**ZONING AMENDMENT
& SUBDIVISION STAFF REPORT****Date: February 7, 2013****APPLICANT NAME**

Savell Subdivision

Subdivision to create 2 lots, and Zoning to rezone the site from R-1, Single-Family Residential, to B-1, Buffer Business, to allow an antique shop.

DETAIL SITE PLAN

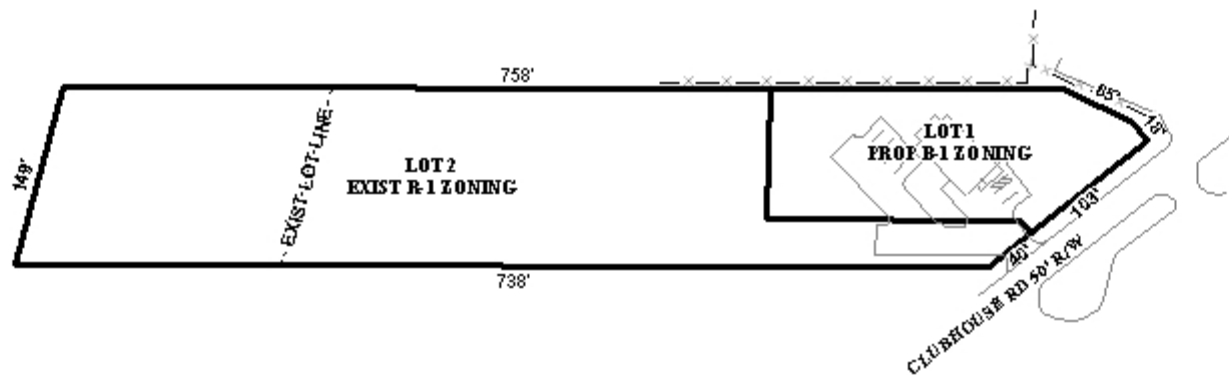
The proposed configuration of the lots will result in Lot 2 becoming a flag lot, of which there is only one in the area, making them an uncommon feature. Furthermore, the proposed Lot 2 does not meet the standards for width-to-depth ratio. Section V.D.3. of the Subdivision Regulations states that lot depth should not exceed 3.5 times the width of the lot at the building setback. As proposed, Lot 2 will be 140' wide at the setback line and 580' deep, resulting in a lot that is approximately 90' deeper than would normally be allowed.

The site plan illustrates both lots having shared access through a 24' wide curb cut on the proposed Lot 2. Because the applicant is proposing to have shared access between two building sites, a Planned Unit Development will be required. This proposed shared access in combination with the proposed Lot 2 being a flag lot make Lot 2 undevelopable.

The 25' minimum building setback line is not illustrated. If approved, the Final Plat should be revised to illustrate and label the building setback line.

Subdivision: The Subdivision request is recommended for Denial for the following reason:

- 1) lot shapes not in compliance with Section V.D.1. of the Subdivision Regulations; and
- 2) lot width-to-depth ratio not in compliance with Section V.D.3. of the Subdivision Regulations.
